CANTERBURY BANKSTOWN
MINUTES OF THE
ORDINARY MEETING OF COUNCIL
HELD IN COUNCIL CHAMBERS
ON 26 MAY 2020

ITEM 5.3 APPLICATION TO AMEND THE CANTERBURY LOCAL ENVIRONMENT PLAN 2012:
165-169 HOLDEN STREET, ASHBURY (ASHFIELD RESERVOIR)

ITEM 5.3 Application to Amend the Canterbury Local Environment Plan 2012: 165-169 Holden Street, Ashbury (Ashfield Reservoir)

Figure 6: LPP Proposed Alterations to Indicative Subdivision (refer annotations below)

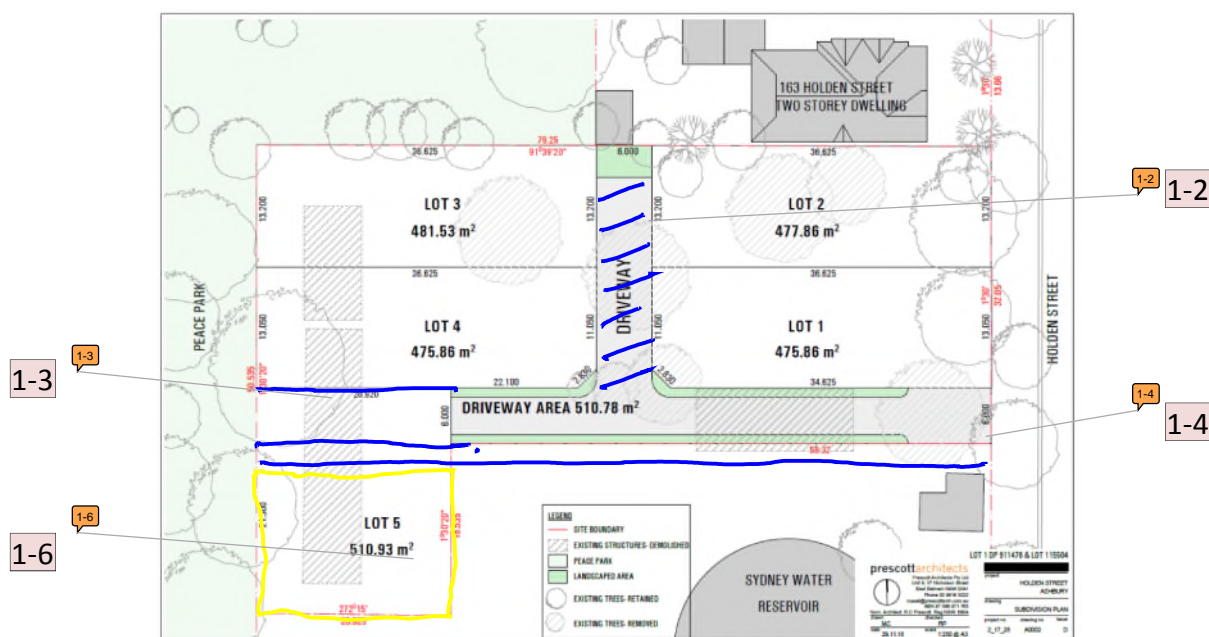
The Panel agrees that a large part of the site can be rezoned low density residential. However, the Panel does not agree that the rezoning should extend to the whole of the proposed lot 5 as shown in the indicative subdivision plan (Refer Figure 6 over page).

In the Panel's opinion the rezoning should be confined to generally the area of lots 1, 2, 3 and 4 with a single east west driveway on the southern side of any proposed lots.

The Panel would have no objections to the southern boundary of the proposed rezoning being extended to the south to enable the east west driveway to include a proper pedestrian access along the length of the driveway to Peace Park which provides a clear line of sight from Holden Street to the park.

- 1-2 Consider deleting and re-orienting lots 3 and 4 to potentially creating a new lot 5.*
- 1-3 Extend driveway*
- 1-4 Widen to provide separate pedestrian path.*
- 1-6 Delete lot 5 and retain current zone except for extended driveway and pedestrian path.*

The Panel recommended the removal of the remaining Lot 5 area as identified by the yellow boundary in Figure 6 previously shown. This area is located behind the heritage item.

Based on the above assessment, Council supports the Panel's recommendation to remove the remaining Lot 5 area, which would reduce the area for rezoning from 2,934m² to approximately 2,540m².

Figure 7: Council land identified to the north of the planning proposal subject site.

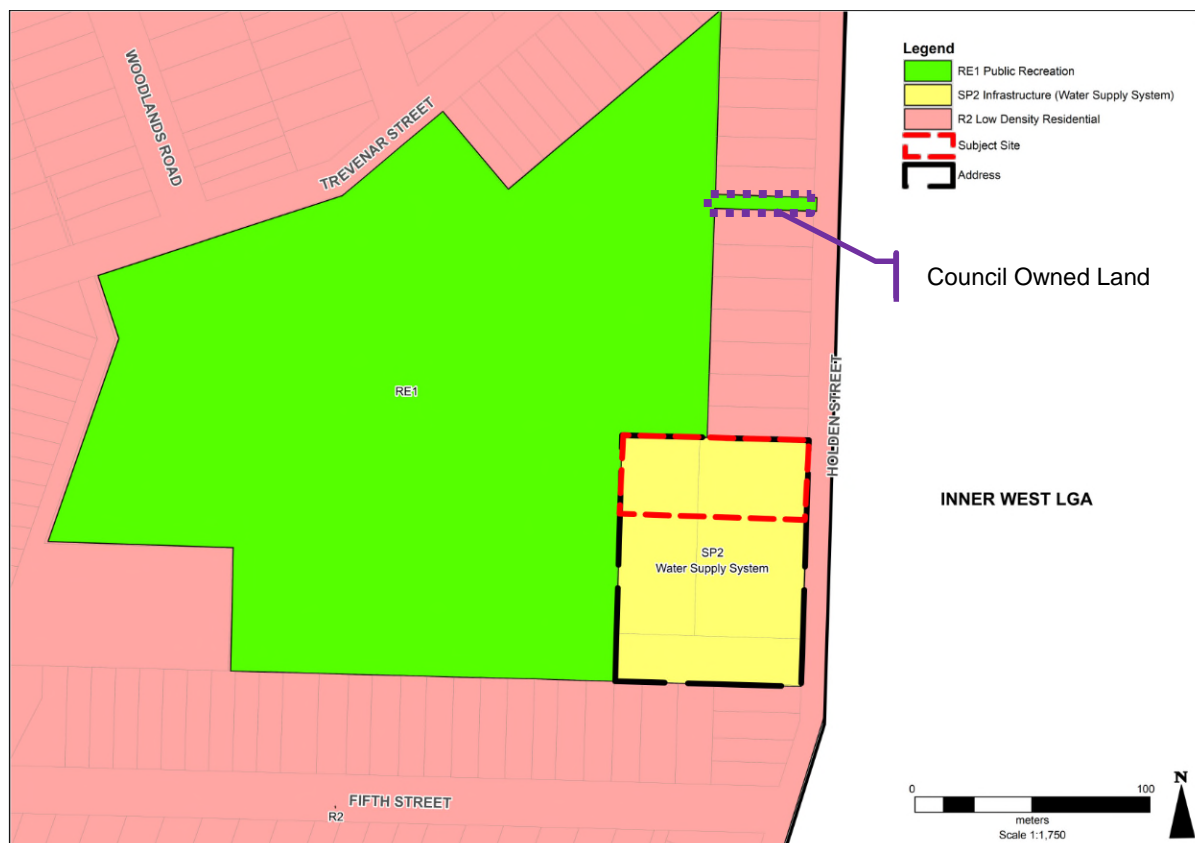
The Panel recommended that an accessway be provided through the subject site. In response, the proponent advised that they do not intend to include the accessway and instead believe Council should promote the current access through the land adjoining 149 Holden Street.

- 6m width x 43m long pathway provides a narrow viewpoint
- 1.8m fences on either side with minimal opportunity for casual surveillance for pedestrians through this path
- Entry to the park at a 'low activity' area with minimal supporting infrastructure.
- Minimal opportunity to acquire and widen the existing path for park users given both adjoining properties contribute to the heritage character of the Ashbury Heritage Conservation Area.

Following the recommendation from the Panel, the subject site is considered a better option for providing access to Peace Park based on the following impediments to opening the existing enclosed connection:

There is merit in creating a link through the subject site as it would create an improved access pathway for the surrounding community and future residents on the subject site and this may be designed appropriately through the DCP.
